Bear Lahai Roi Subdivision Sockeye Run View Addition KPB File 2022-074 Segesser Surveys / Huber Nikiski Area

ITEM 7 - BEAR LAHAI ROI SUBDIVISION SOCKEYE RUN VIEW ADDITION

KPB File No.	2022-074
Plat Committee Meeting:	July 18, 2022
Applicant / Owner:	Paul and Suzette Huber of Kenai, AK
Surveyor:	John Segesser / Segesser Surveys
General Location:	Kenai Spur Highway, North Woods Street, Nikiski

STAFF REPORT

KPB File # 2022-074 S19 T08N R10W Nikiski

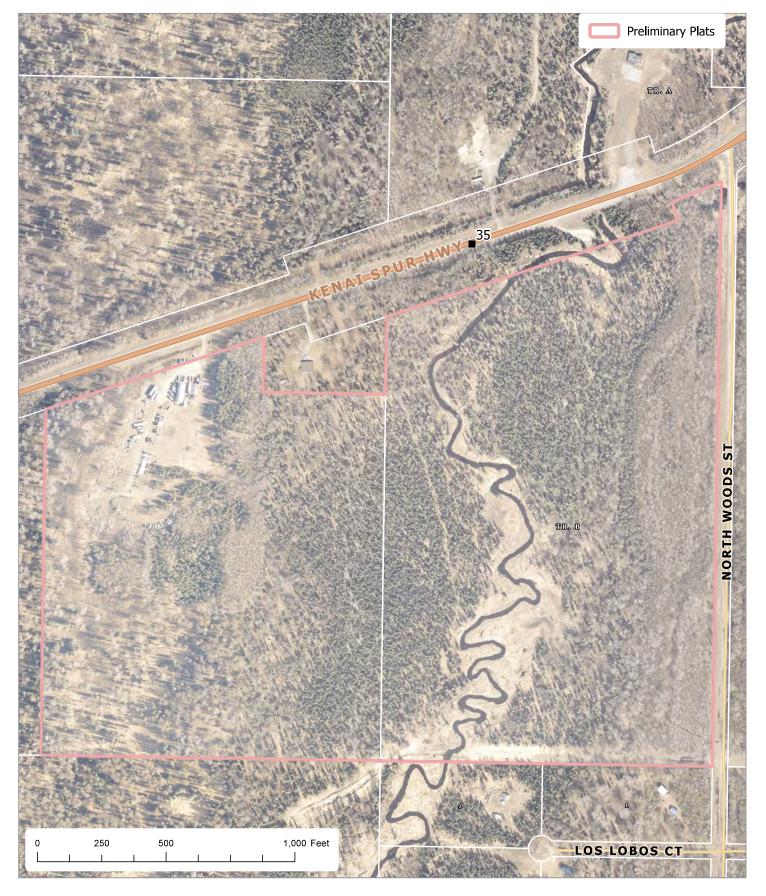
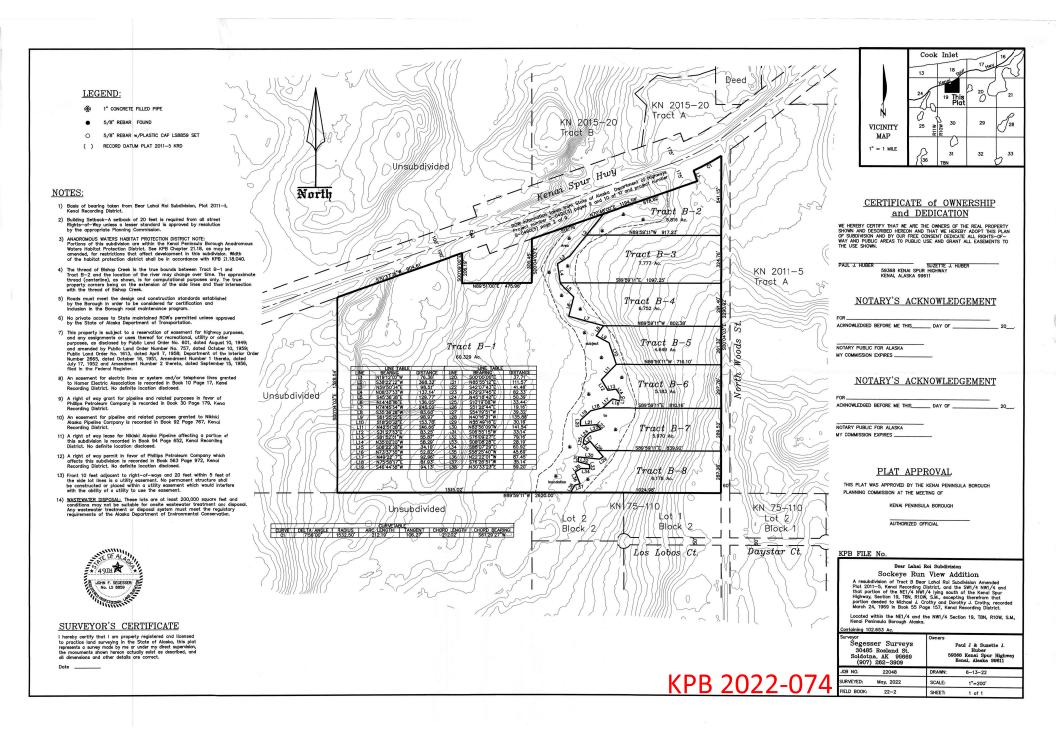
<u>Site Investigation:</u> Contours are present on the preliminary plat. There are areas within Tract B-1 that appear to exceed the 20 percent slope. Some steeper slopes appear to also be present within the eastern tracts as they slope towards Bishop Creek and the associated wetlands. **Staff recommends** slopes greater than 20 percent be shown on the final plat as they may impact development.

Bishop Creek is being used as the boundary between Tract B-1 and the other tracts being created. This is an anadromous stream. There are wetlands depicted within the dotted line that are adjacent to the creek. Those low wet areas are classified as Riverine. Additional areas of low wet areas of kettle and discharge slopes are present. **Staff recommends** the creek name be indicated on the face of the plat as it is mentioned in notes and all low wet areas be depicted and a wetlands determination note be added.

Several recorded easements have been granted and are noted within the plat notes. Several of the easements have location descriptions present within the documents. **Staff recommends** any known locations of easements be shown on the plat with a reference to the plat note or the document granting the easement be added.

The parent plat, Bear Lahai Roi Subdivision Amended, KN 2011-5, granted and depicted numerous utility easements. **Staff recommends** all easements from the parent plat be carried over unless it can be demonstrated that the easements no longer exist.

HEA	Depict and label the existing overhead primary electric line and provide a 30 foot wide easement centered on the existing overhead line.	
ENSTAR	No comments or recommendations	
ACS	No objections	
GCI	Approved as shown

Staff recommendation: The excluded lot should be labeled. The lot to the southeast, along Daystar Court, has been replatted and the depiction and label should be updated. A plat has been submitted to the east of North Woods Street. Prior to printing the mylar the status should be reviewed to determine if the depiction and labels need to be updated.

Plat note 4 should be revised as there are additional tracts than what is listed in the note. Label Bear Creek as such and add note to (see note #4)

Plat note 5 may be removed unless rights-of-way are dedicated.

Plat note 12 had an additional assignment that should be added, serial number 2017-00133-0, KRD. Line labels L2 and L28 should be divided for the two lots being crossed.
